Technical Memorandum

| Title | Thompson Street, Bowen Hills Response to EDQ Further Issues Letter | | |
| Date | 4 February 2021 | Status | Final |

Figure 1-1 Active Transport Facilities

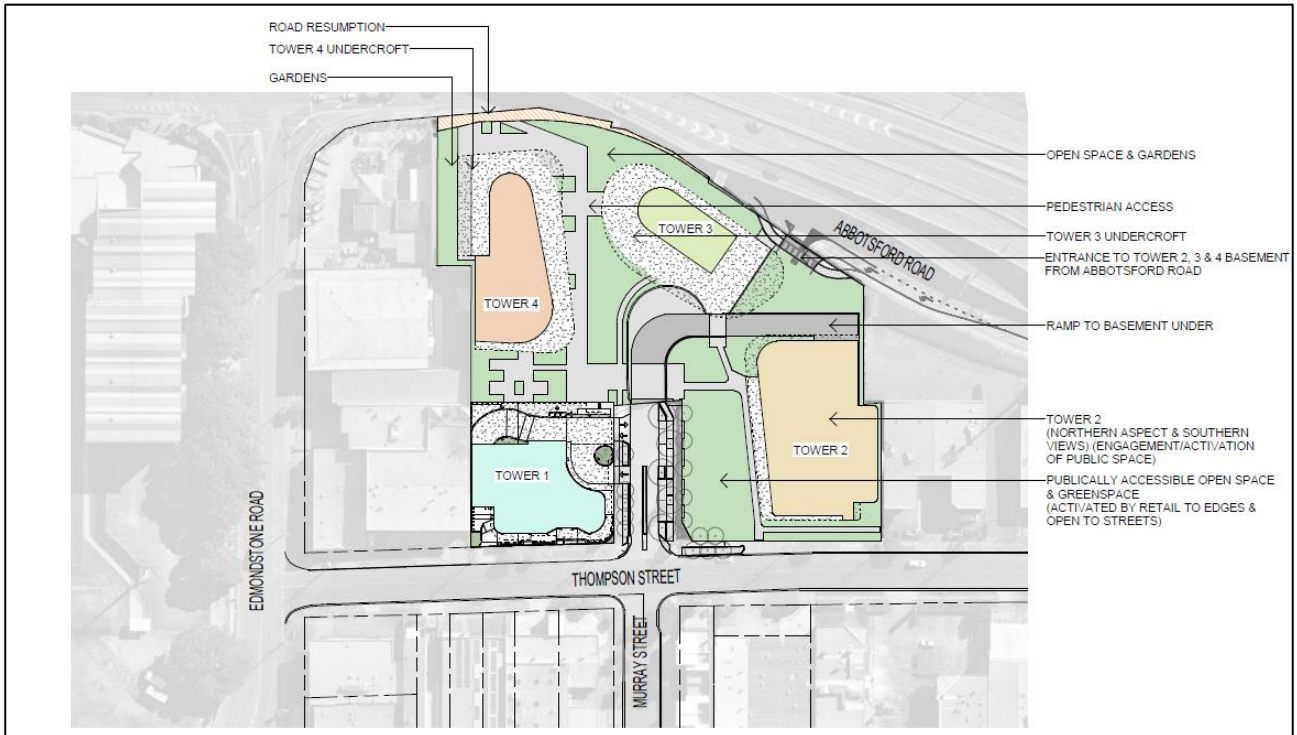
On site car parking numbers are to be in accordance with City Plan 2014 - Transport, Access, Parking and Pedestrian and cyclist access to the site should include consideration of the routes provided to end of trip facilities. The proposed Plan of Development (PoD) also indicates a pedestrian link to Abbotsford Road between towers 3 and 4, however it would also be desirable to have a link between towers 2 and 3.

Provide an amended traffic report demonstrating pedestrian and cyclist access to the site.

The updated masterplan has been amended to take account of the various comments by EDQ. As part of this pedestrian connectivity between towers 2 and 3 have been provided.

With regard pedestrian and cycle access to the site, active transport connections have been provided from the door of each tower to existing pedestrian facilities on Murray Street and Thompson Street. Further to this the future stages of the masterplan are envisaged to connect into the proposed Abbotsford Road Cycle facilities that are planned by EDQ.

These active transport facilities are outlined in Figure 1-1 below

Figure 1-2 Refuse Strategy

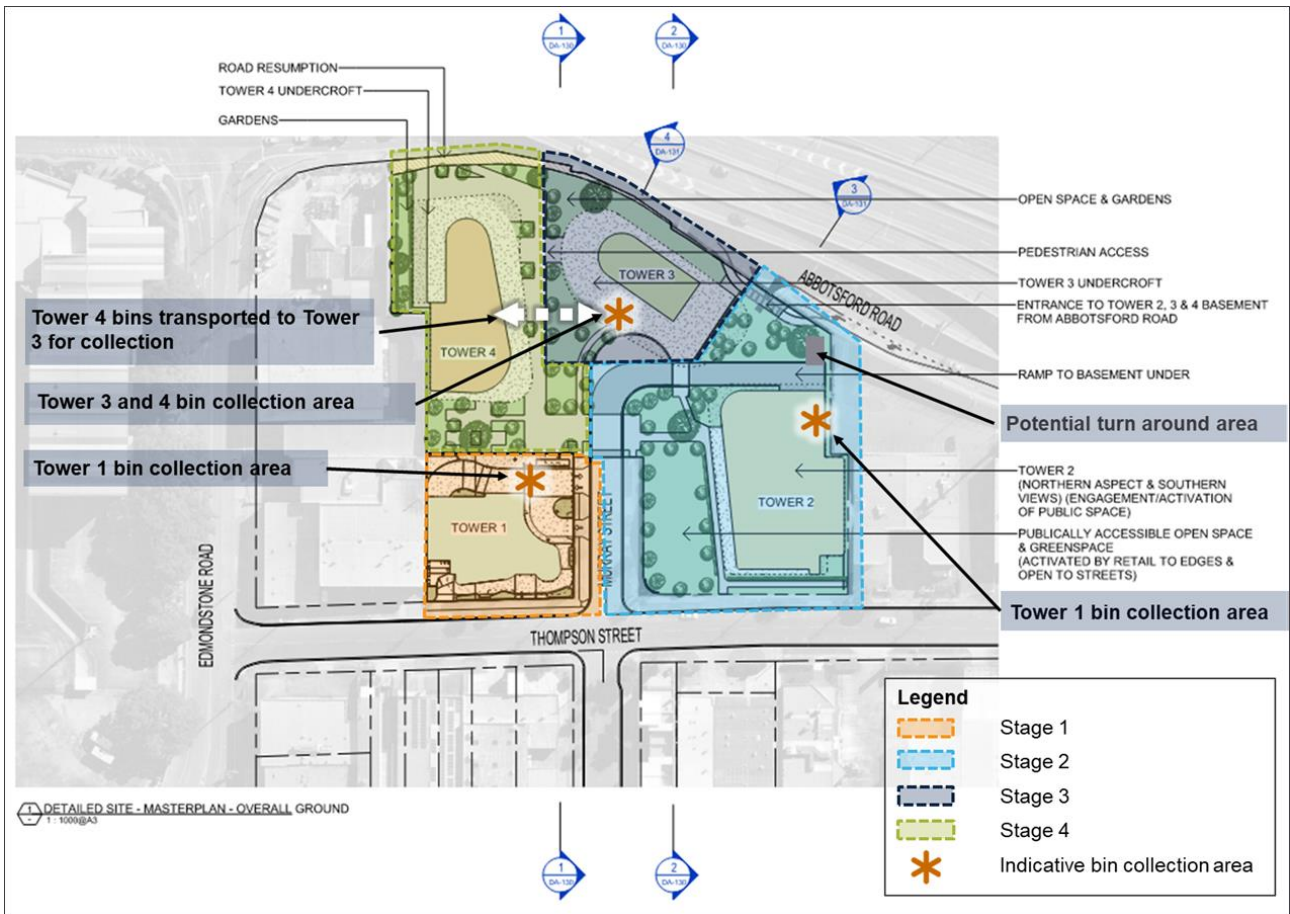
Provide an overall site master planned refuse management strategy, including any staging proposed for refuse management in accordance with BCC requirements, certified by a suitably qualified person that outlines how waste management will be implemented for the overall site including staging considerations. The refuse management strategy needs to demonstrate access from Murray Street only as access from Abbotsford road is not supported.

Cardno has reproduced the Refuse Management Plan prepared in the previous Further Issues Response. This management plan was prepared with the assumption that all service vehicle access would be via Murray Street and no access from Abbotsford Road was envisaged.

While the refuse servicing details for future stages will not be known until the building designs are developed, the high level refuse management strategy is proposed in Table 1-3:

This strategy is broadly illustrated on the figure 1-2 below.

With the private road being delivered as part of Stage 2, access for Stages 3 and 4 will already be constructed. It will be the responsibility of the site manager to transport the bins for Towers 3 and 4 to and from the storage areas to the collection area on collection days. This may require use of a ride-on transport vehicle with trailer for the bins.

The frequency of refuse collection has not been determined at this stage, however it is acknowledged that collection may need to occur more frequently than once per week. Should the collection area for Towers 3 and 4 not be large enough to accommodate bins from both towers, collection days may need to be staggered for each tower.
